MEMORANDUM

SUBJECT: Traffic access to the proposed Ridge Heights Subdivision

CITY COUNCIL WORKSHOP

ACTION REQUESTED: City Council direction on the possible modification of City adopted Street Standards for the Ridges area of the City of Grand Junction.

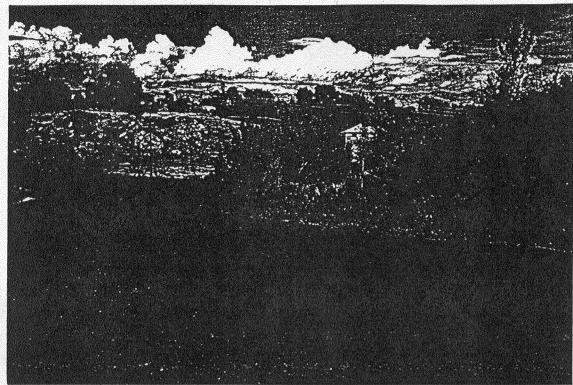
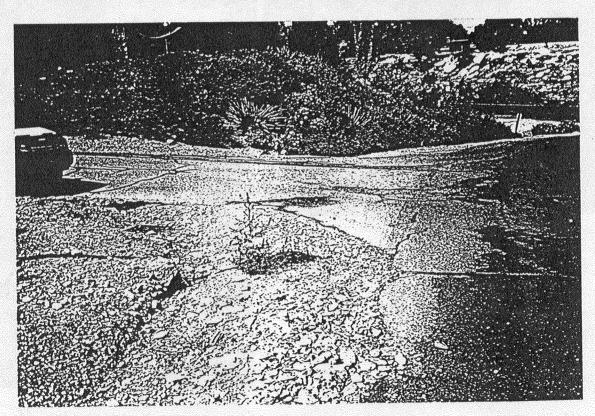
The culvert placed in the ditch for driveway access is probably undersized to carry the flow of water required. Inadequate cover over the pipe is the likely cause of the concrete driveway failure evidenced by the cracks in the concrete. The end of the pipe shows some damage from vehicles. Gravel from the shoulder has washed onto the pavement. The timbers separate the landscaping from the ditch, leaving the area between the pavement and the timbers an unattractive area.

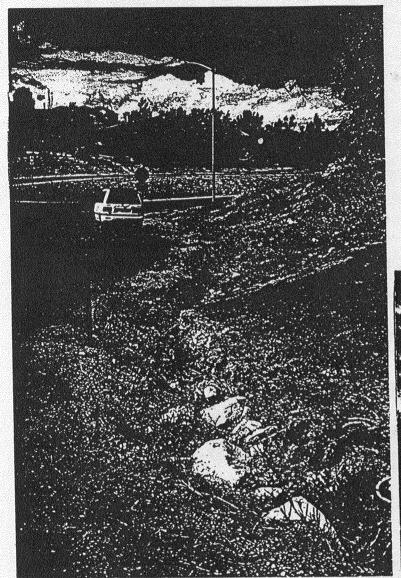
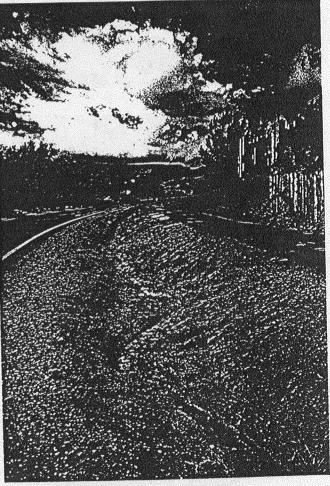
Vegetation has reduced the capacity of the ditch, forcing stormwater onto the pavement.

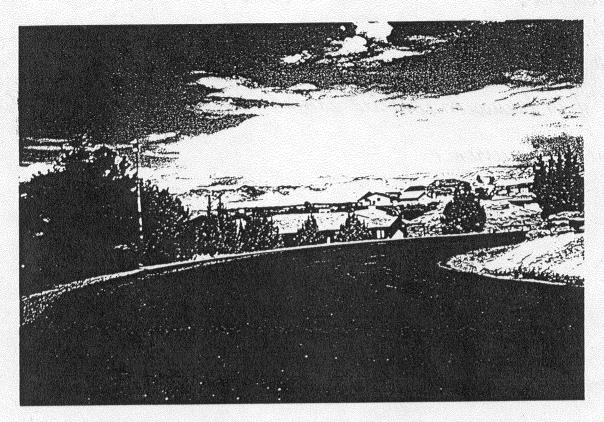
Gravel from the roadside has washed onto the pavement. The roadside ditch must be regraded so water will reach the storm inlet. Gravel from the ditch is being washed out onto the pavement. Behind the inlet, material has eroded away from the edge of pavement. Vehicles traveling too close to the edge may drop a tire off the pavement and pedestrians may stumble.

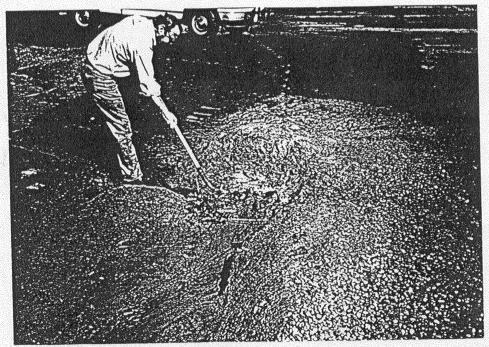
The delineator marks the outlet of a culvert into the ditch. Erosion in the ditch has carved an irregular path, and eroded the edge of the pavement. There is a significant drop-off from the pavement into the ditch. In the second photo, shoulder material has been placed along the pavement edge, but erosion is occurring along the path.
